Field Modification FM22007

VS2.5 (3 PS): Replacing UG69* and NAPS43* with UG132 and NAPS58A

Issue 1.0 11 January 2023

FIELD MODIFICATION

Figure SD-4

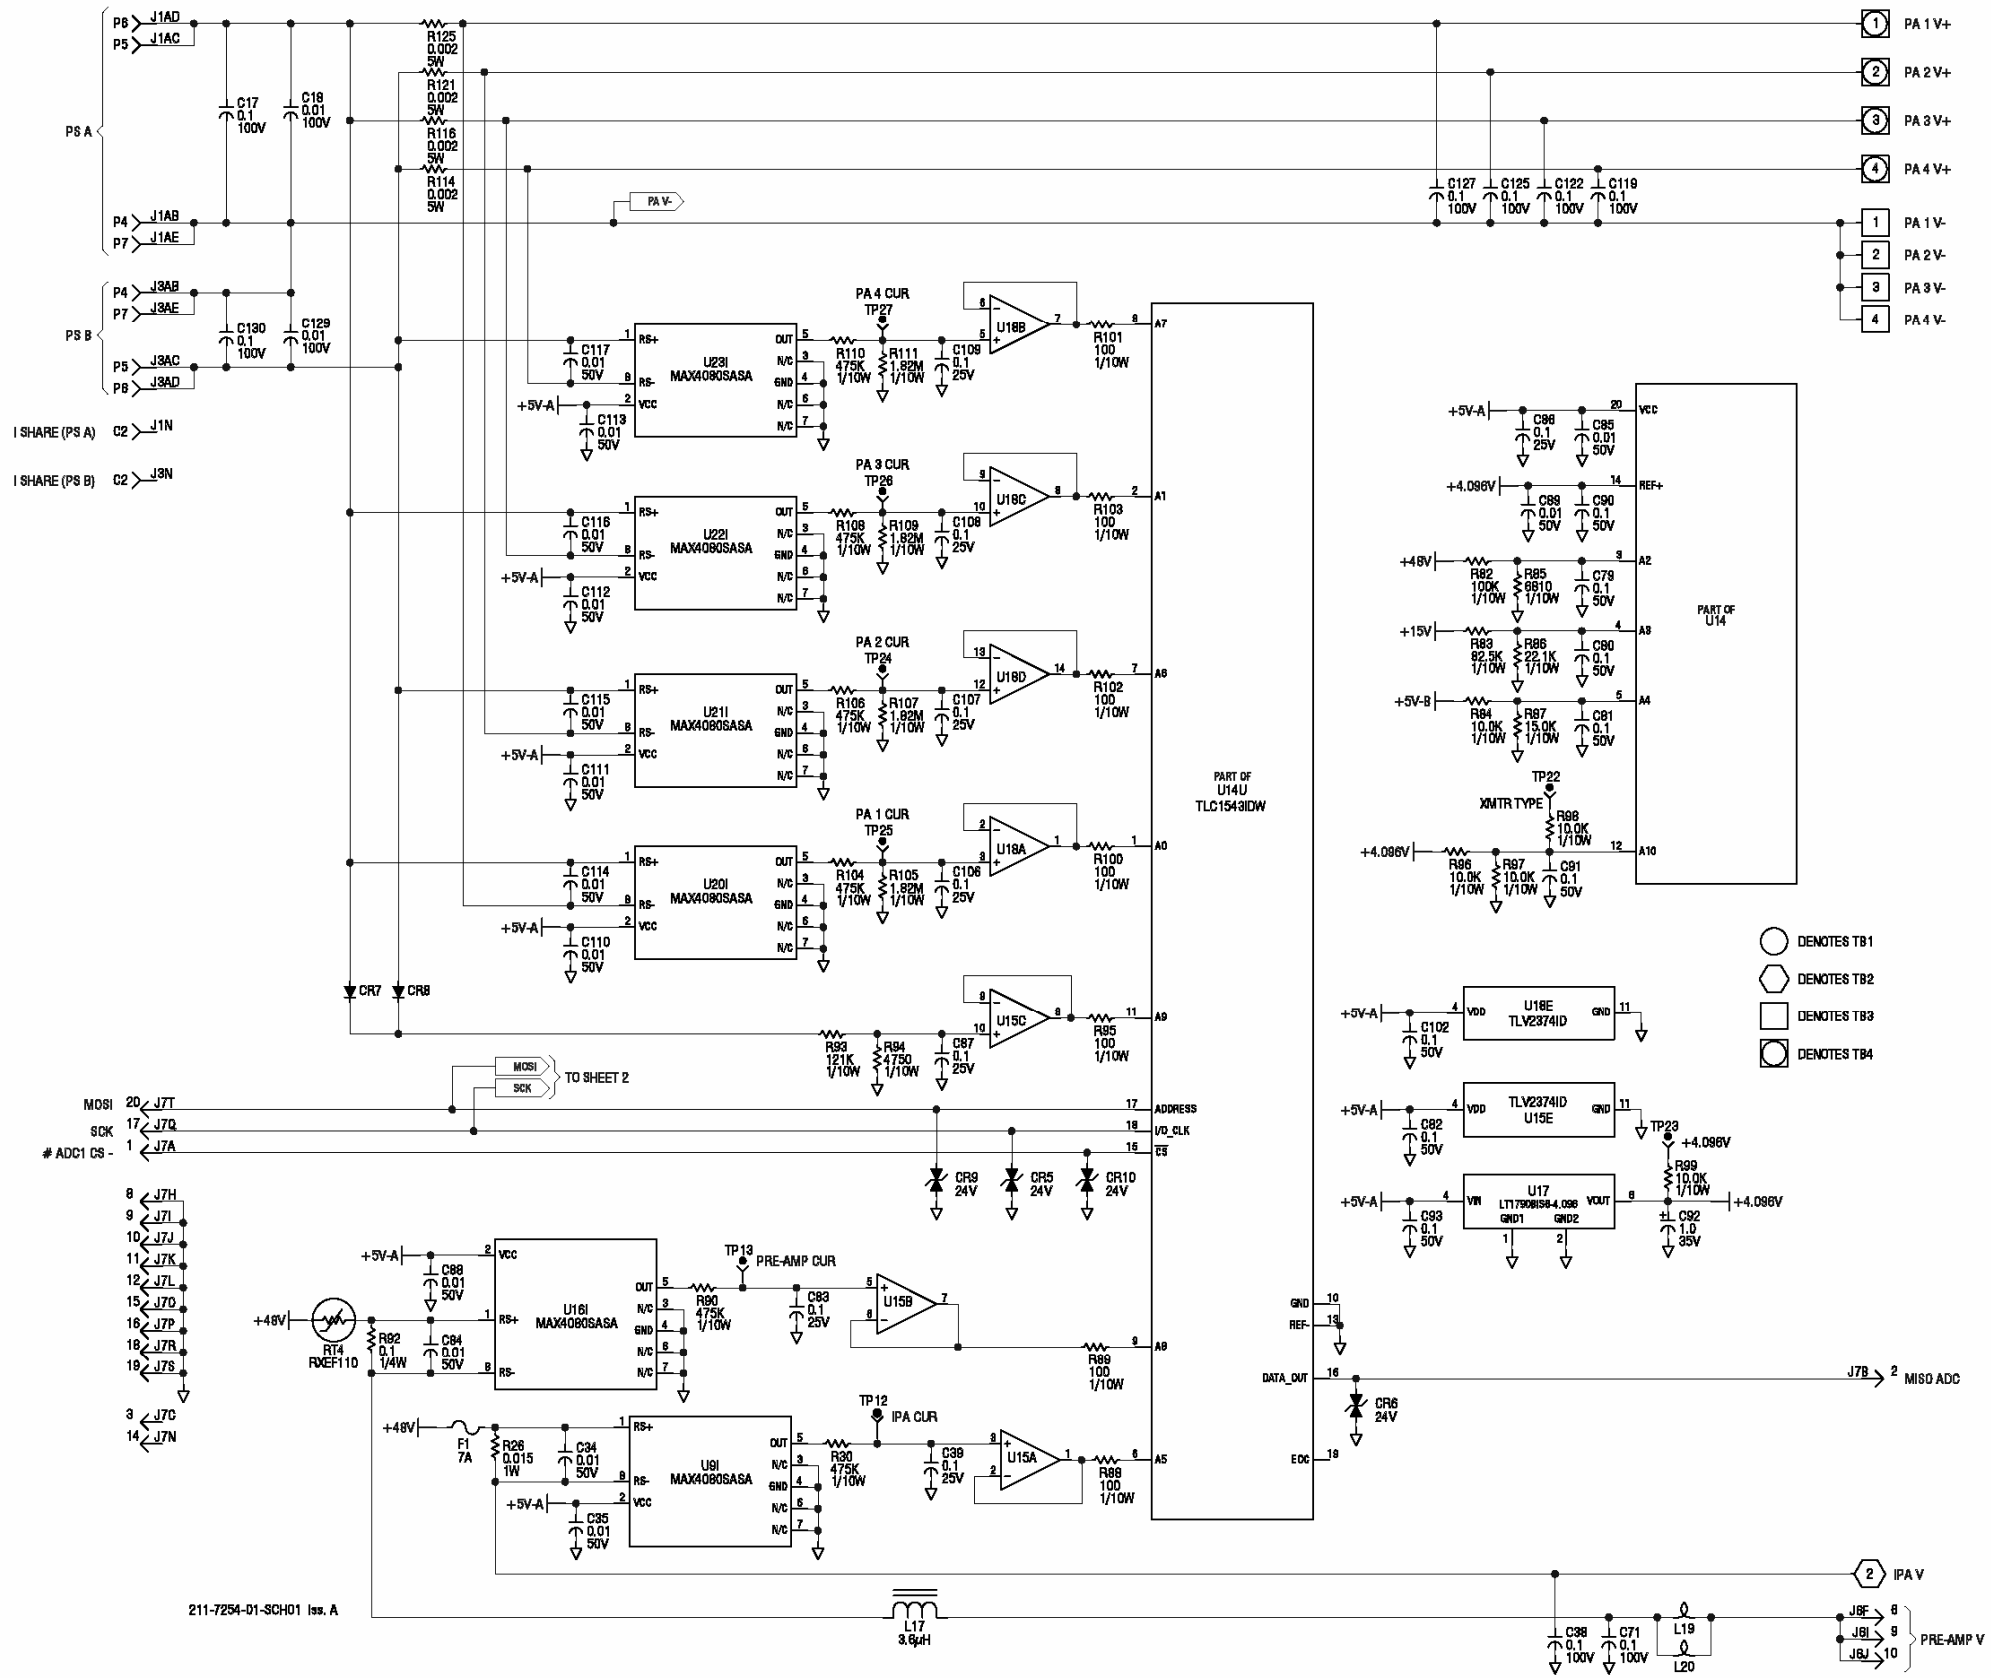
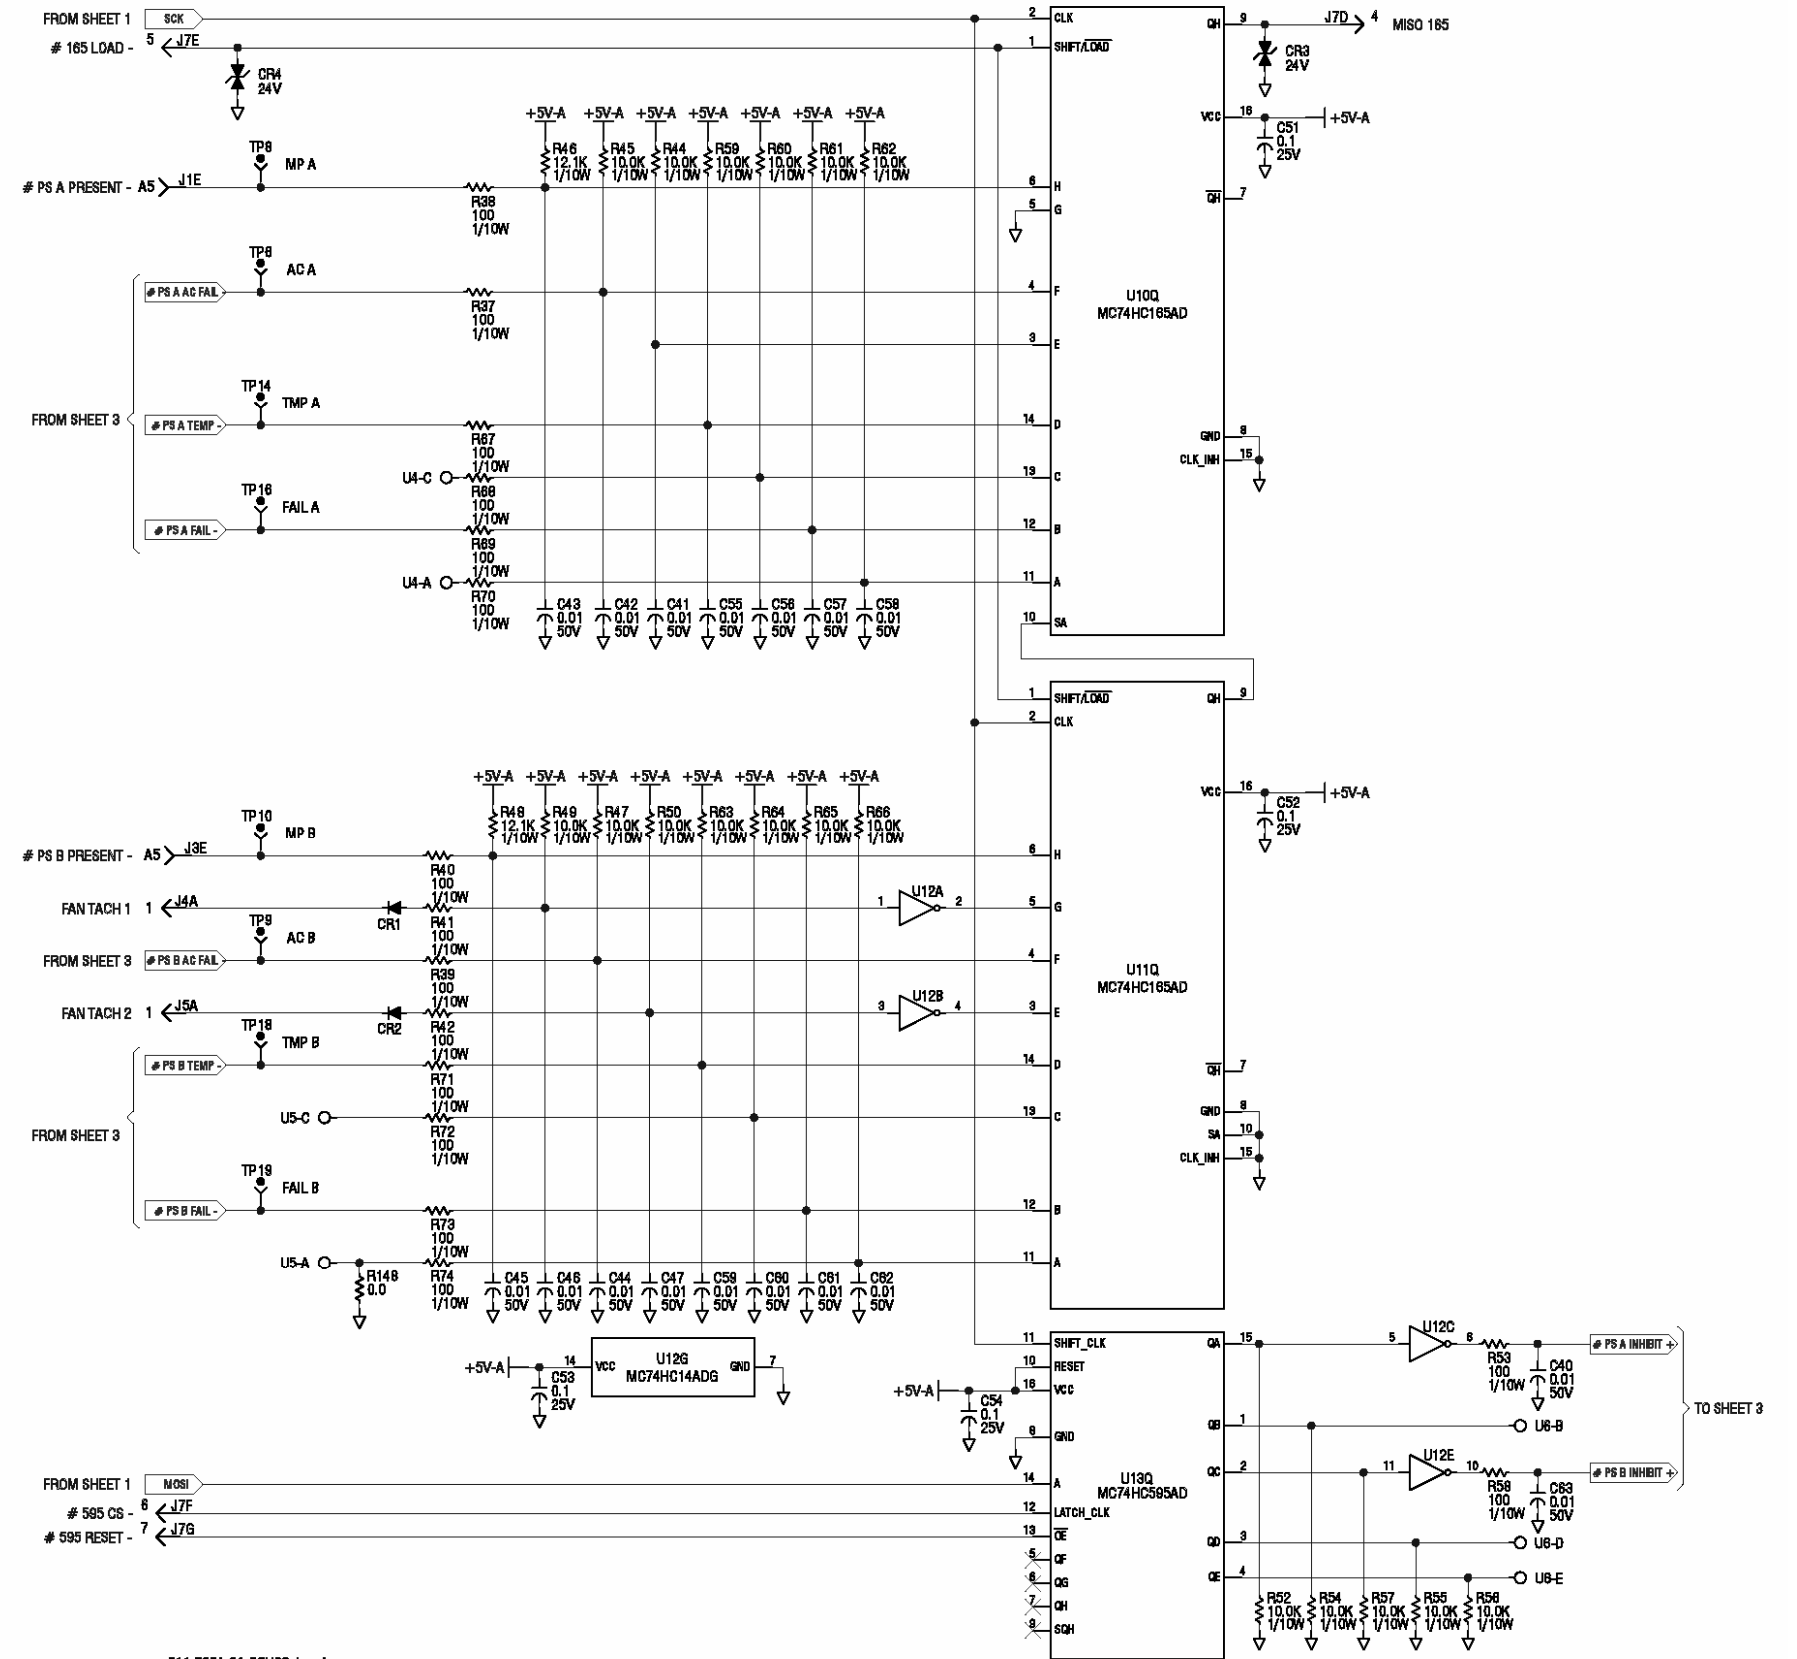
- Section 5 – Electrical Schematics:
 - In Table 5-1, the NAPS43* references for SD-4 and SD-5 change to NAPS58A.
 - Electrical schematic SD-1: note that Power Supply Module U2 is not used.
 - Electrical Schematics SD-4 and SD-5 change to the schematics (SD-4, SD-5, SD-5A and SD-5B) attached to this document.
